Addendum No. 2

Subject: Henry Lawton School Classroom Modernization Renovation
SDP Contract Nos. 2022-007-G, 2022-007-P, 2022-007-E

Location: Henry W. Lawton School
4501 Benner Street
Philadelphia, Pennsylvania 19135

This Addendum, dated 17 of February, 2022, shall modify and become part of the Contract Documents for the work of this project. Any items not mentioned herein, or affected by, shall be performed strictly in accordance with the original documents.

4 VCT FLOOR PATTERN @ BUILDING ZONE 'A' - ROOM #107
A-132 SCALE: 1/4" = 1'-0"

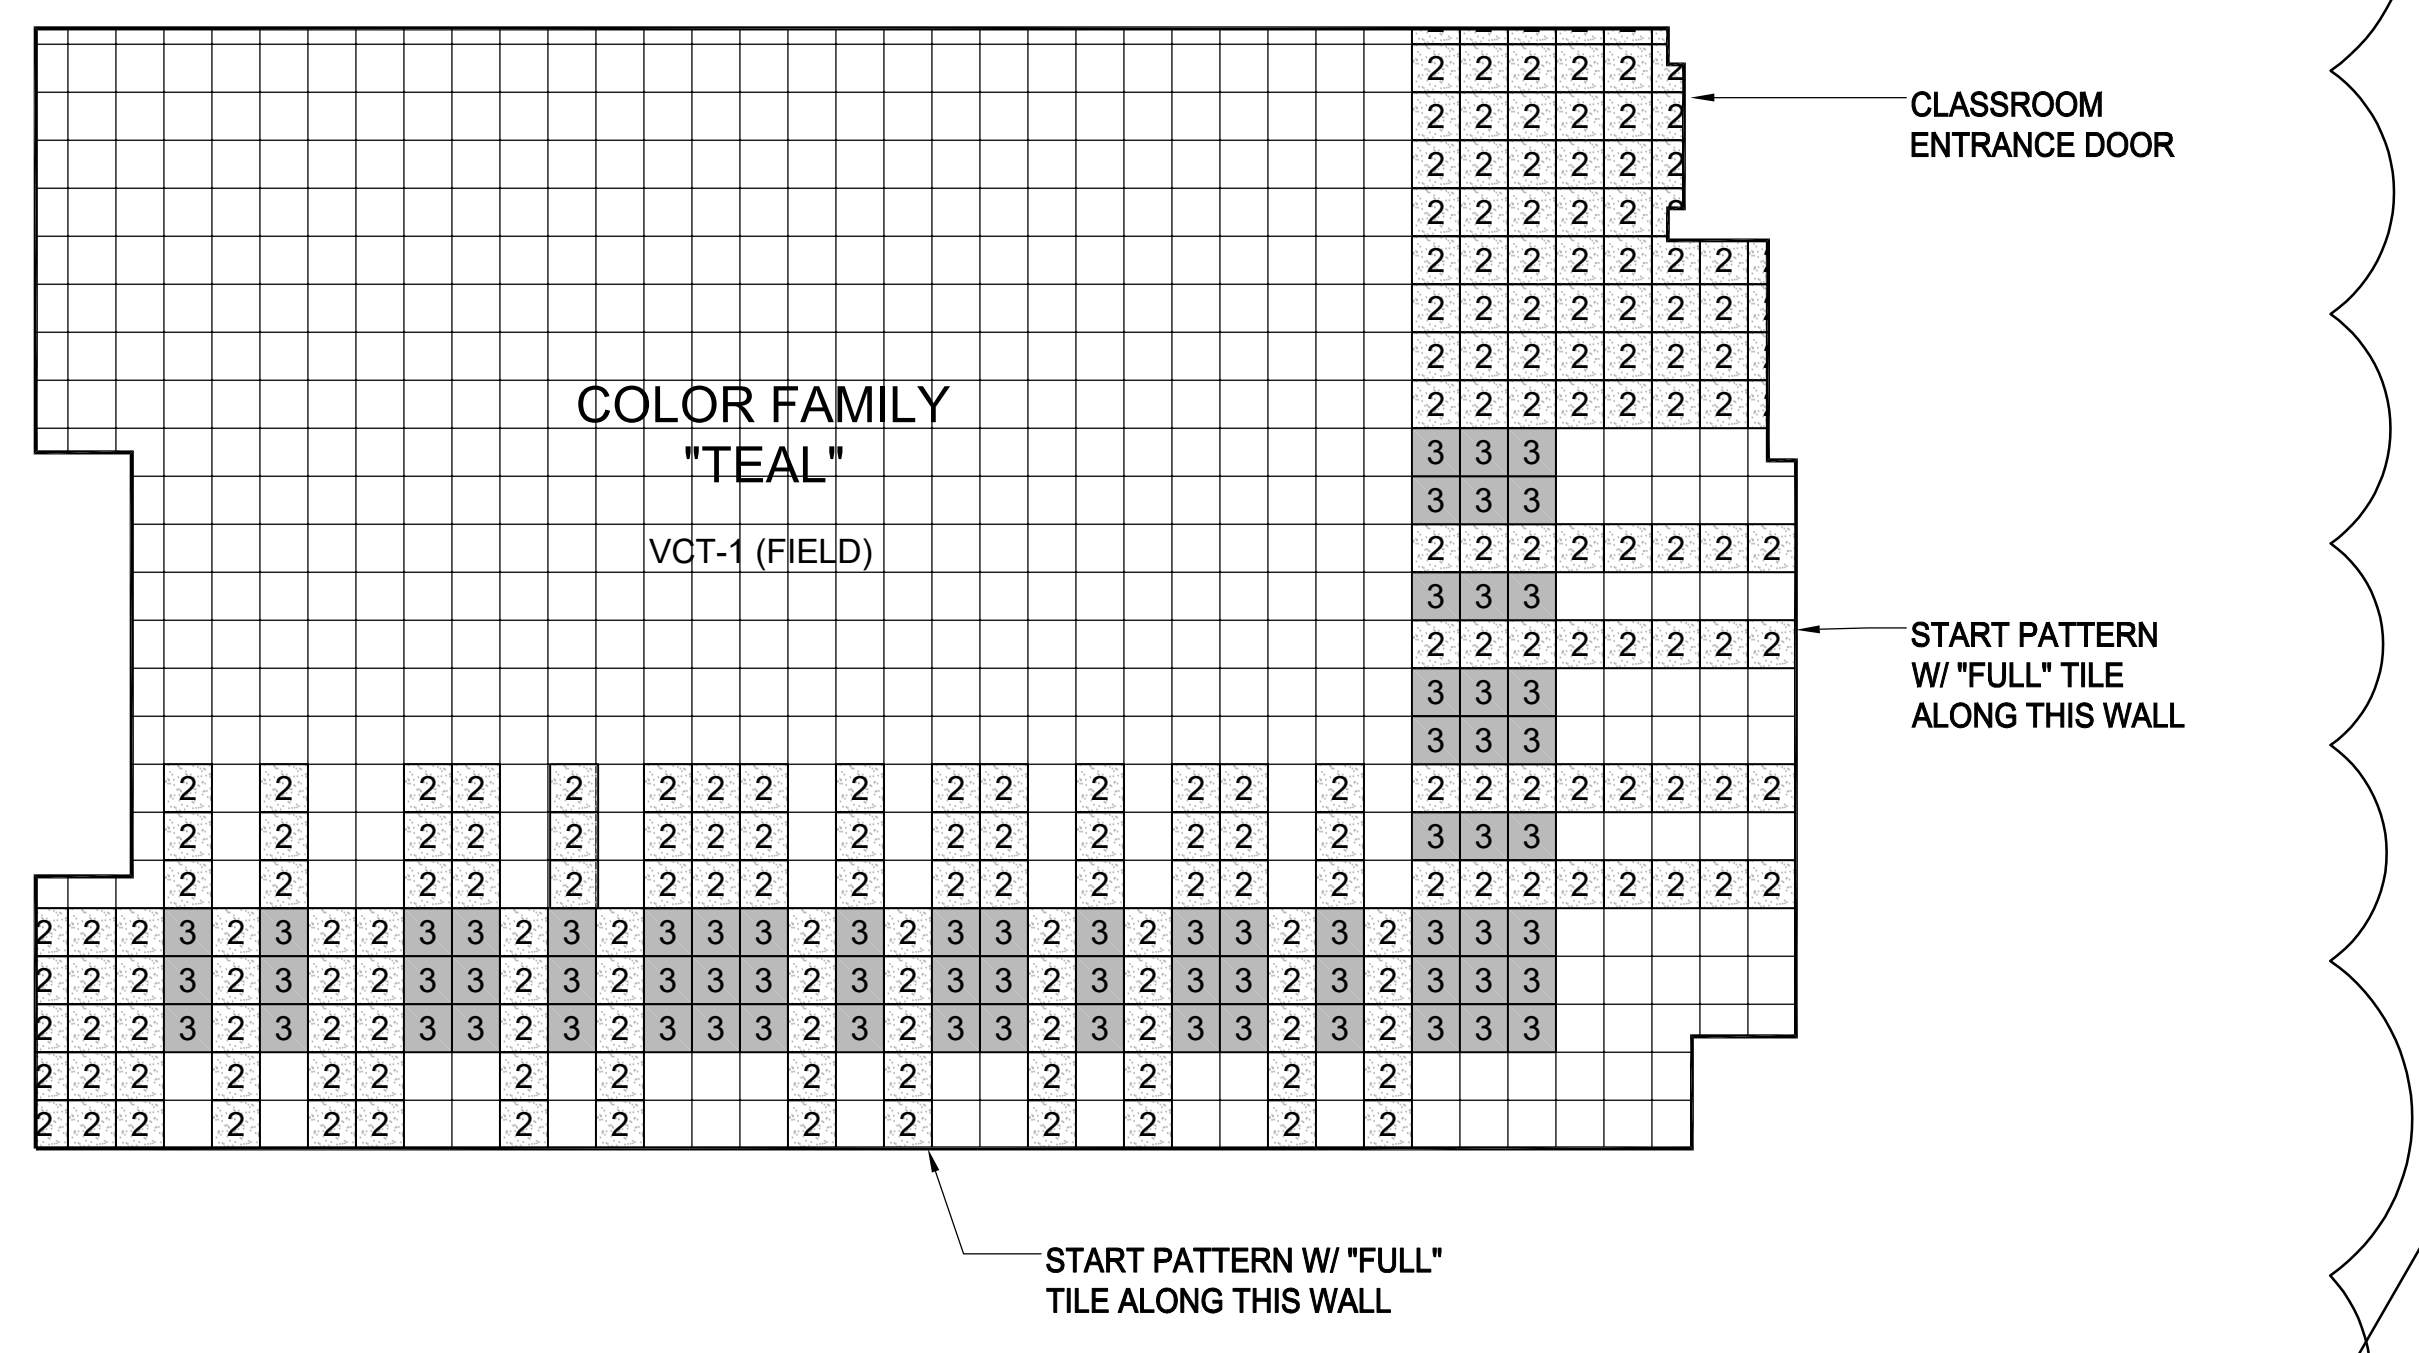
1. MODIFY Detail 4 as indicated on drawings.
2. MODIFY Detail 5 as indicated on drawings.

DRAWING NO.
A - 401
SHEET 15 OF 43

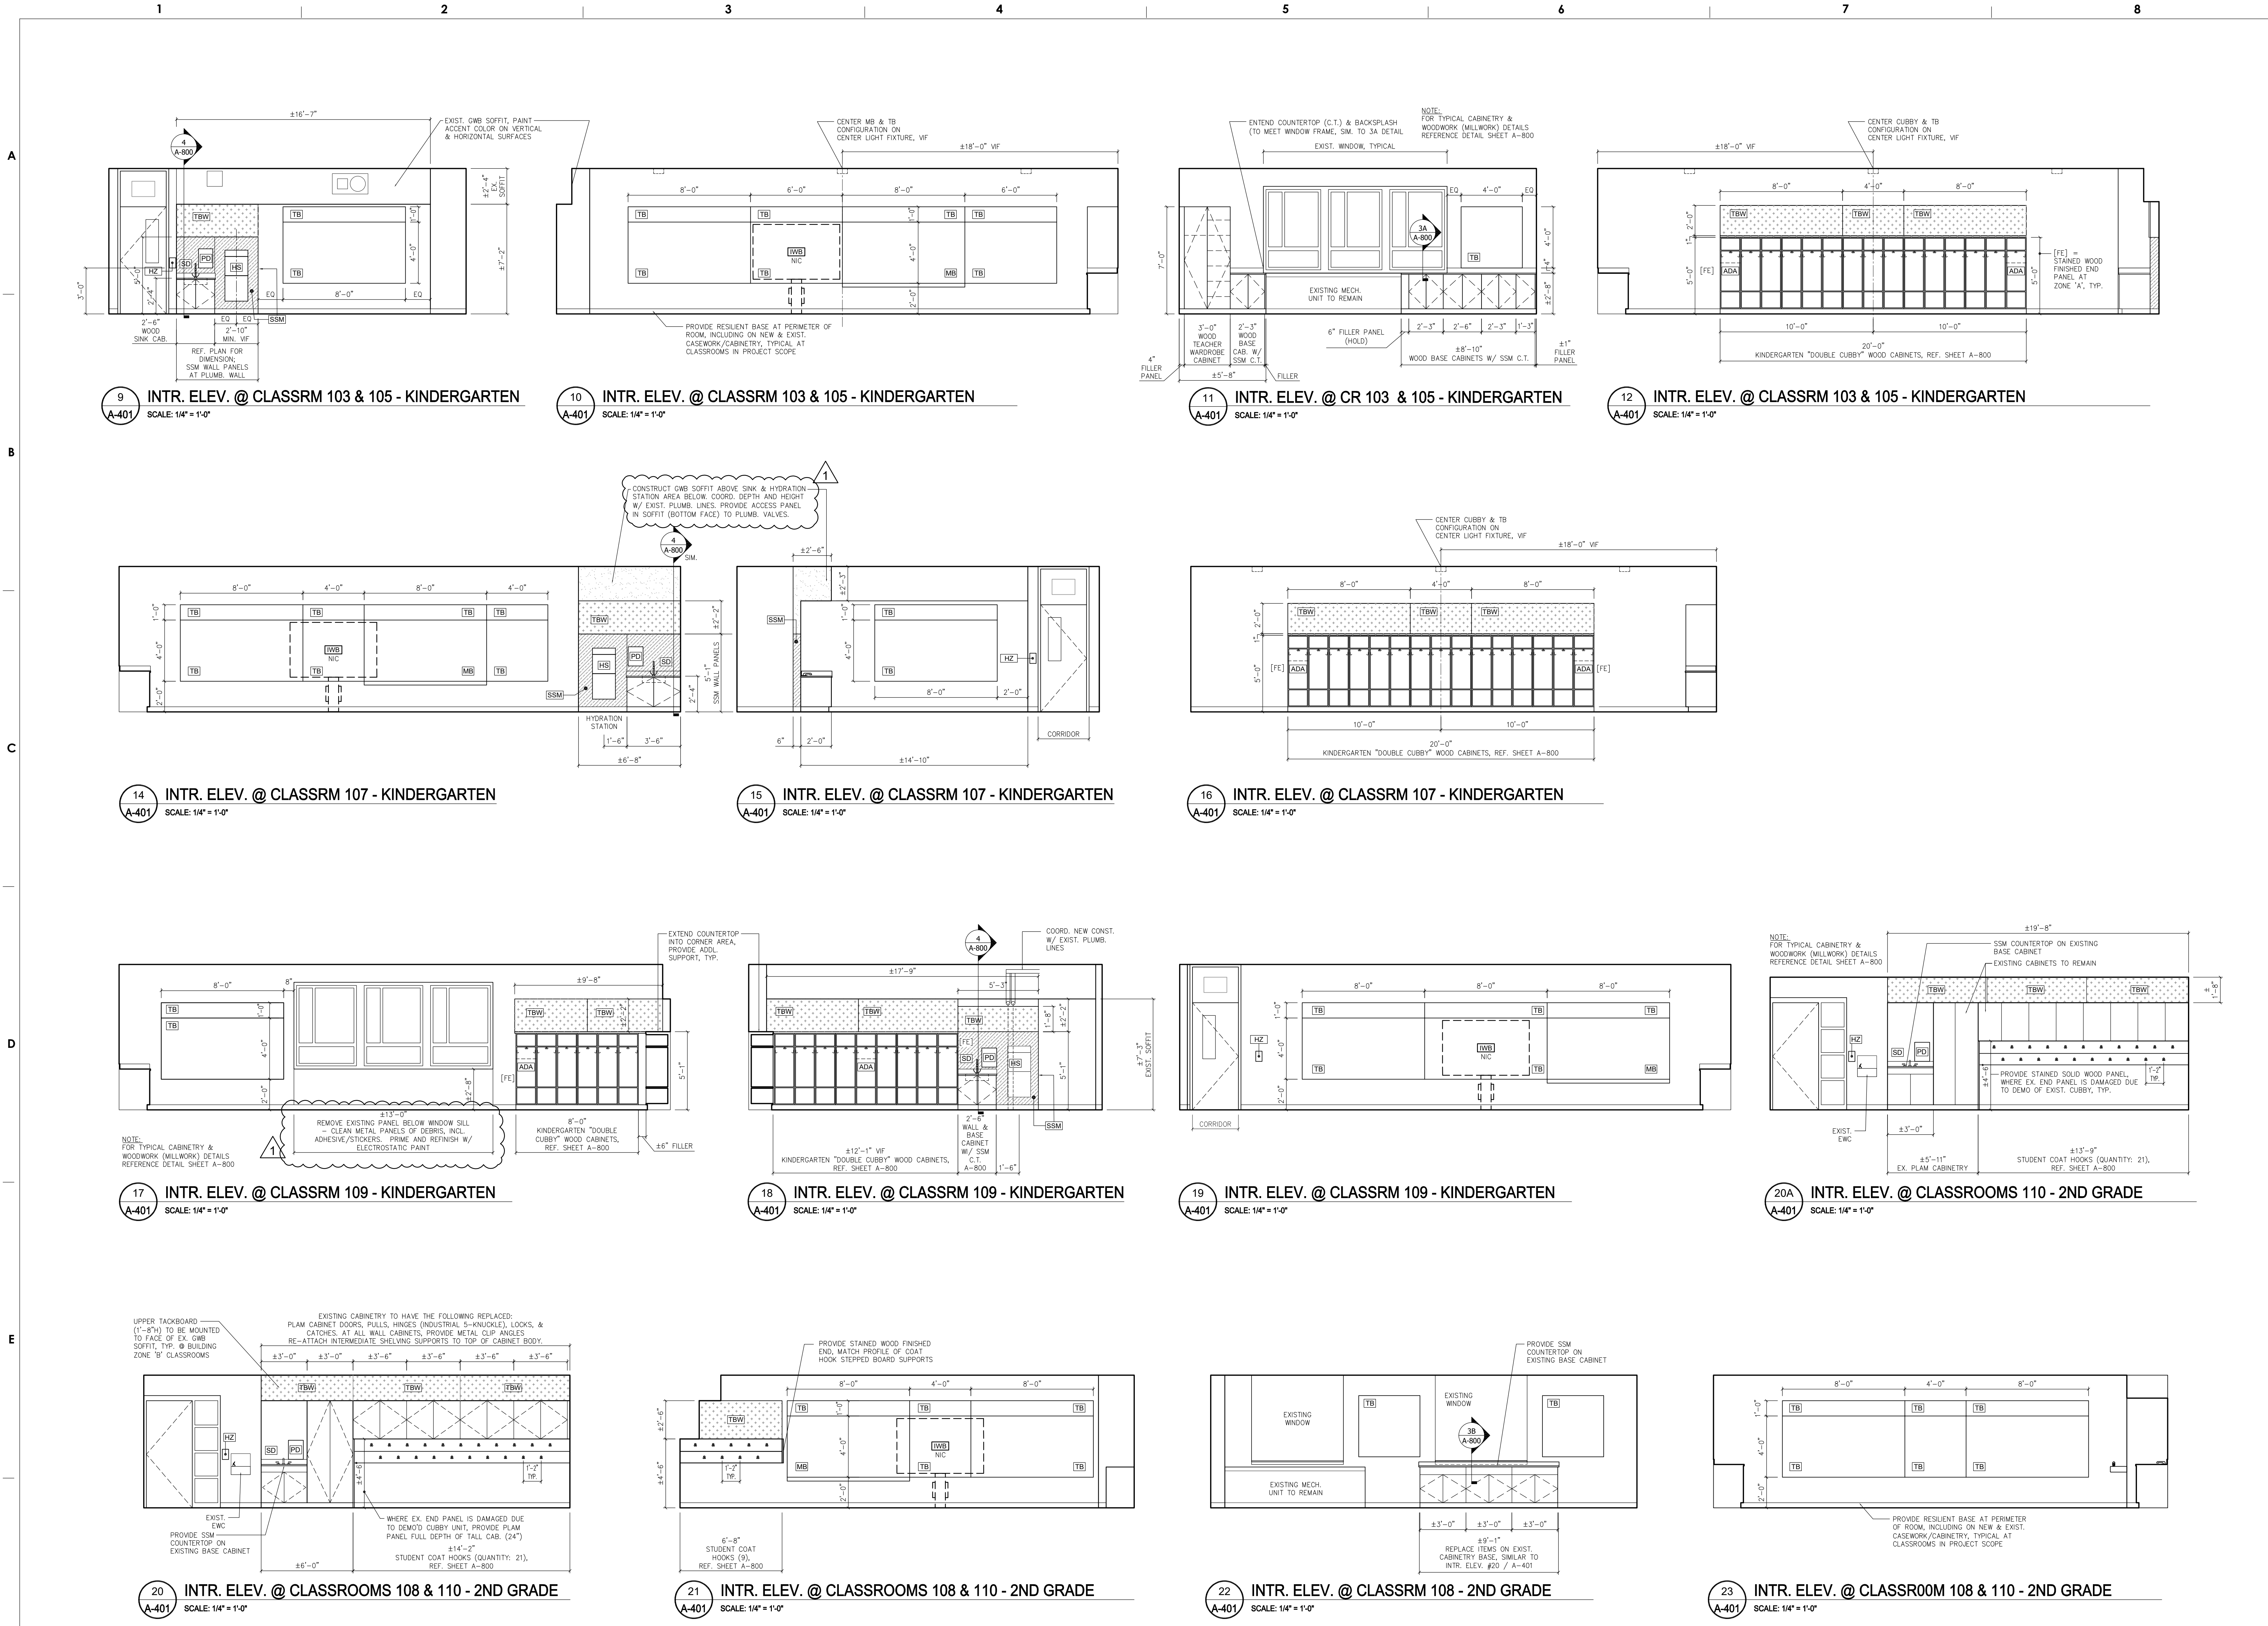
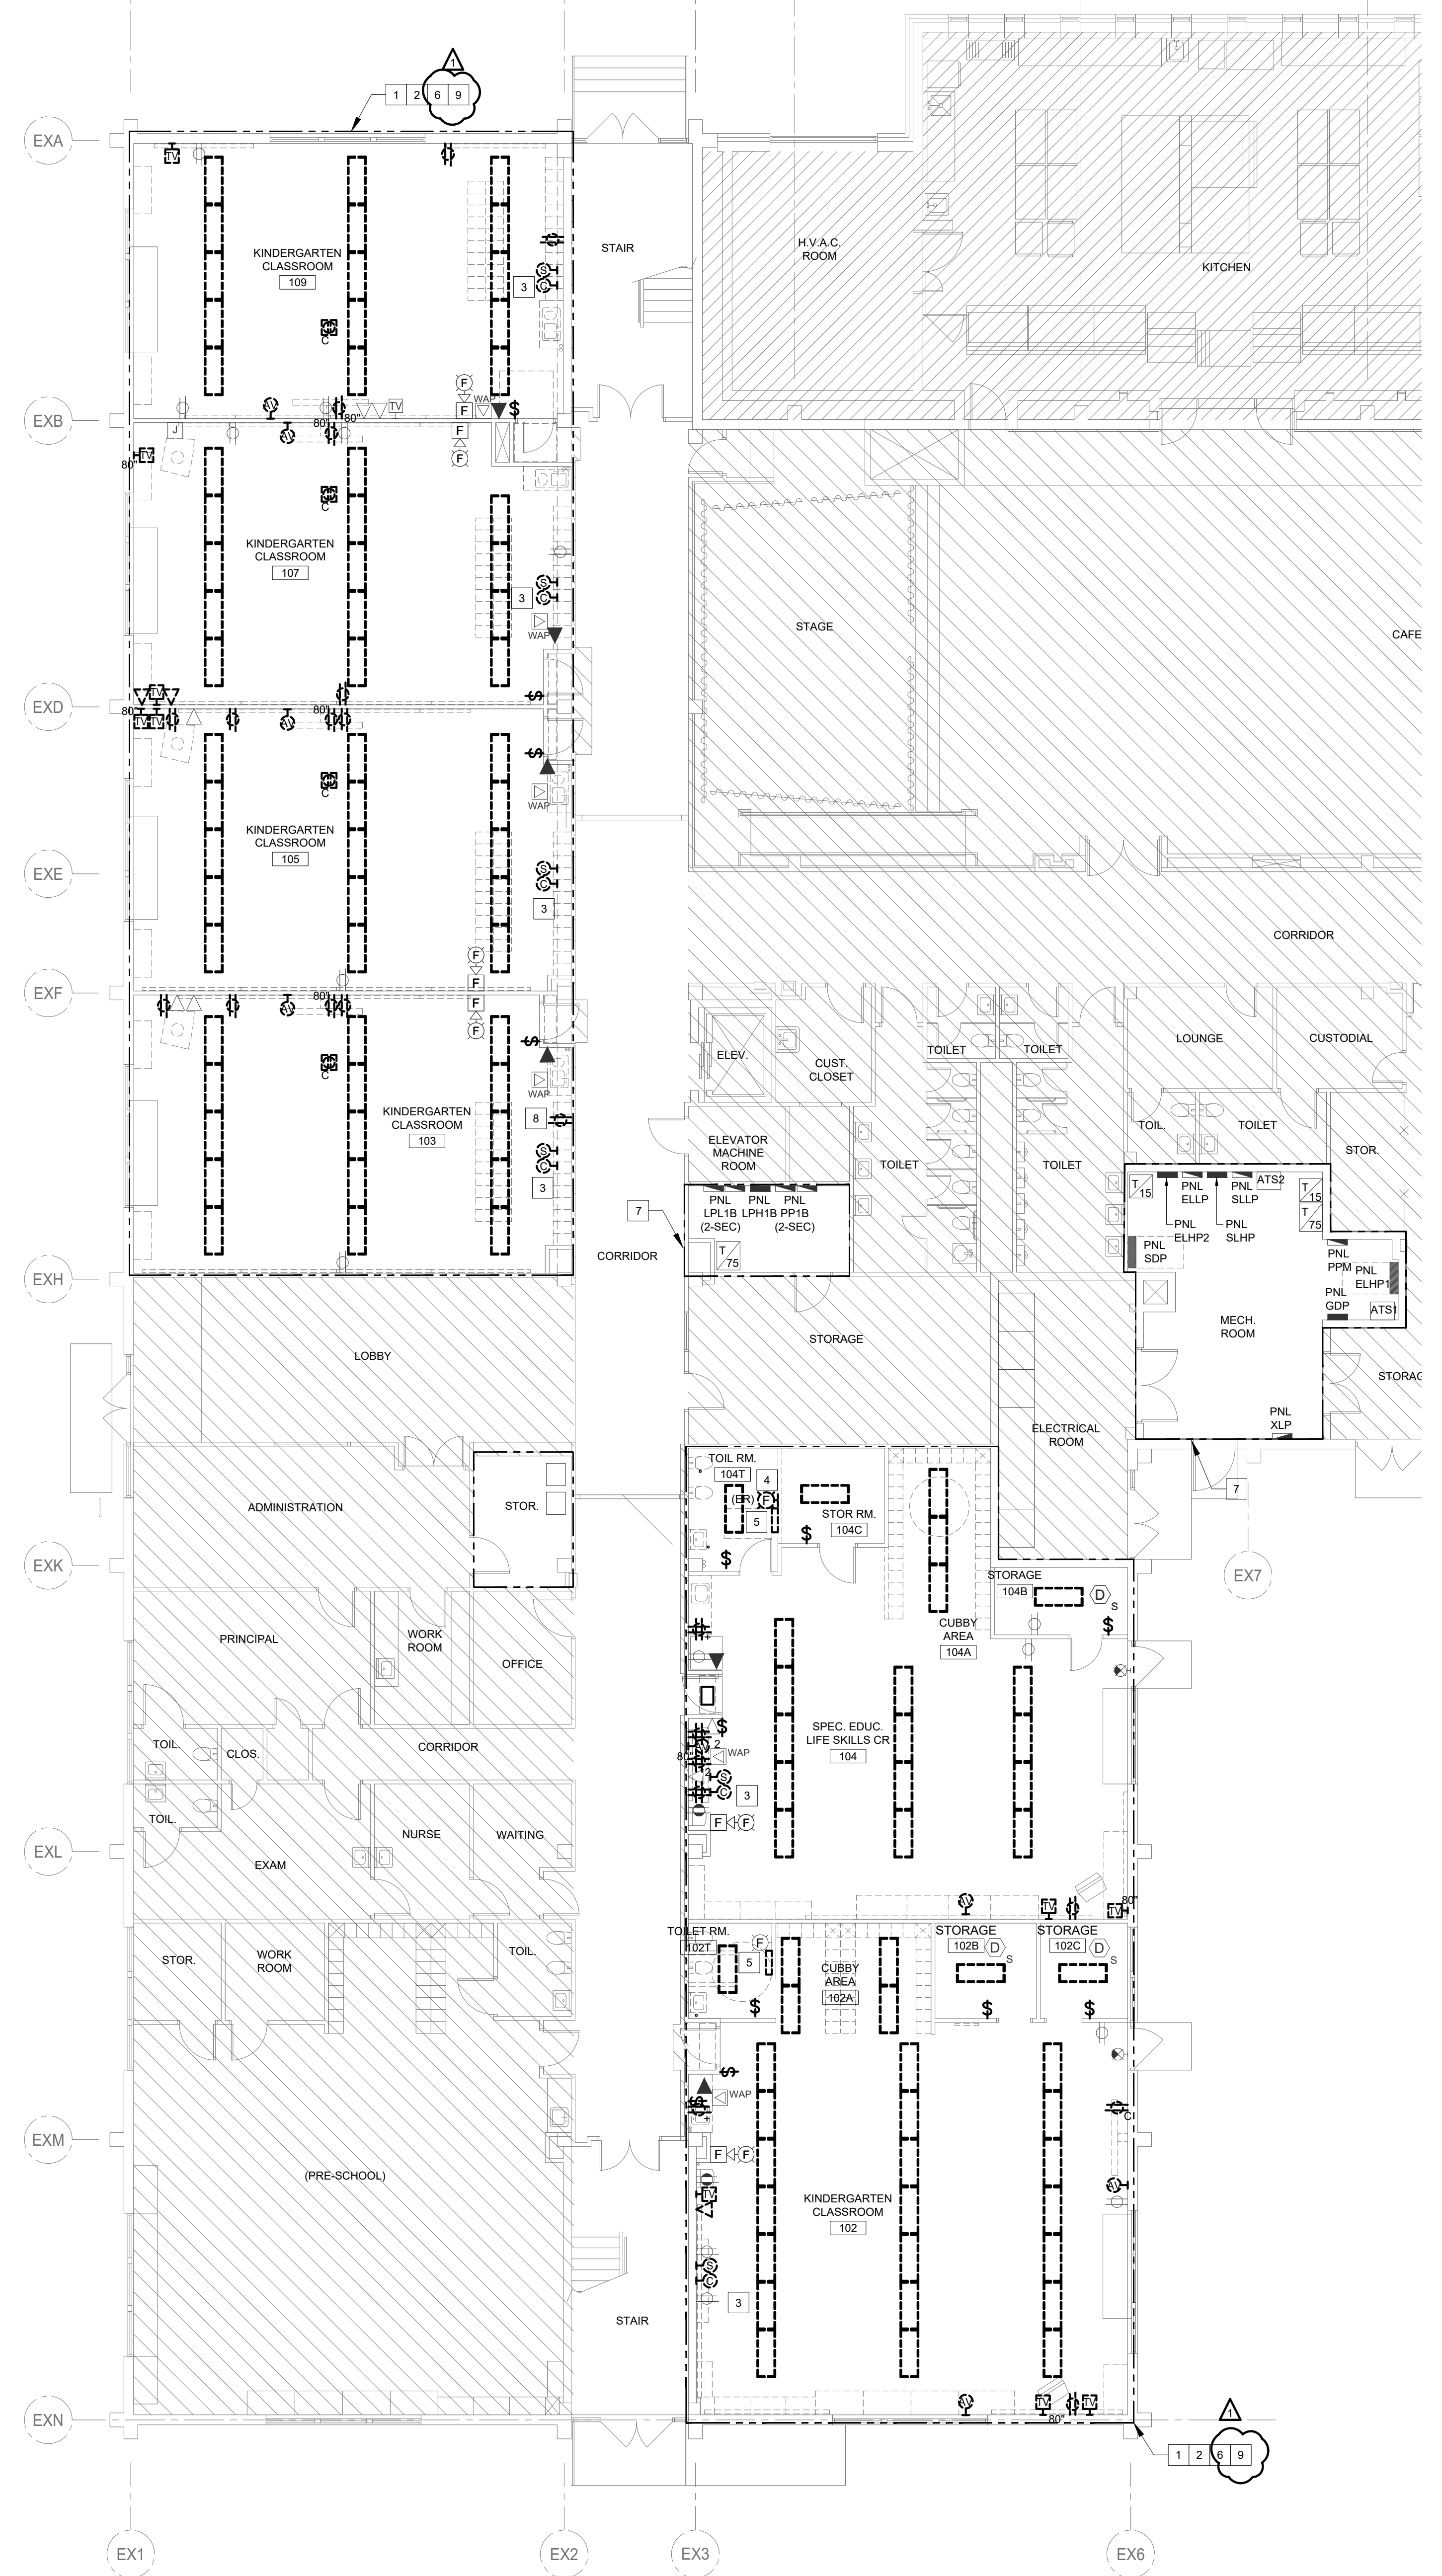
1. MODIFY Details 14 / 15 as indicated on drawings.

2. MODIFY Detail 17 as indicated on drawings.

Question 4: Please indicate on drawings and finish schedule those items that are to receive electrostatic painting specified in section 10 51 15.

Answer 4: Electrostatic painting takes place on the metal shelving in Classroom 112 and the metal panels in Classroom 109. See updates to Drawings A-130 and A-401 attached.
